**BROWNS FERRY NUCLEAR PLANT (BFN) - UNITS 1, 2, and 3
EMERGENCY PLAN IMPLEMENTING PROCEDURE (EPIP) REVISIONS**

TVA is submitting this notification in accordance with the requirements of 10 CFR Part 50, Appendix E, Section V. Specifically, several EIPs were revised: (1) EPIP-2, Revision 24; (2) EPIP-3, Revision 27; (3) EPIP-4, Revision 26; (4) EPIP-5, Revision 31; and (5) EPIP-11, Revision 9. The revisions have an effective date of August 26, 2002.

EMERGENCY PLAN IMPLEMENTING PROCEDURES (EPIP) REVISIONS
EPIP-2, EPIP-3, EPIP-4, EPIP-5, AND EPIP-11

ATTACHMENT C (Page 1 of 1)
 PROTECTIVE ACTION RECOMMENDATIONS

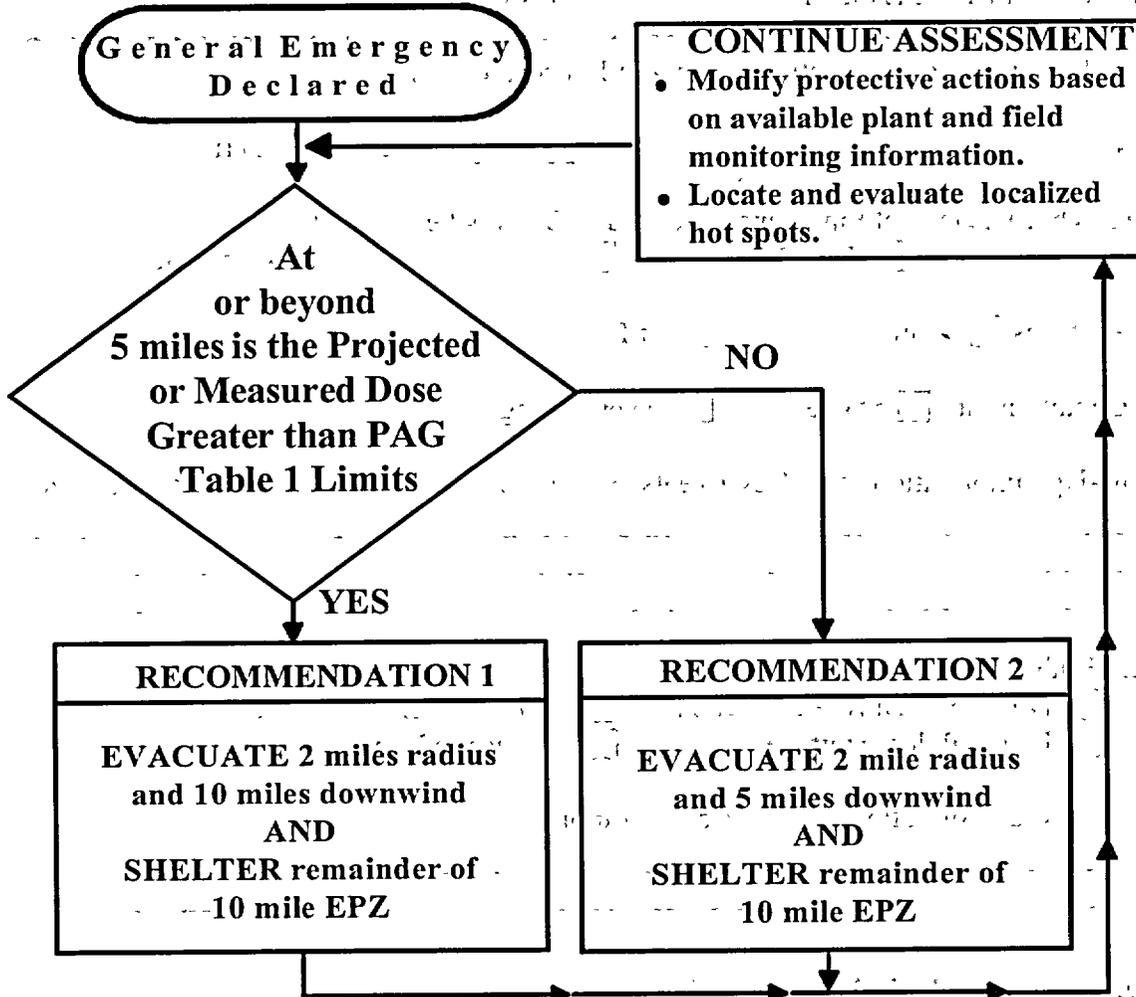
- Page 10 - revised to update information supporting Unit 1 Operator actions regarding ERO staffing support.
 - Page 11 - revised Protective Action Recommendation Flowchart
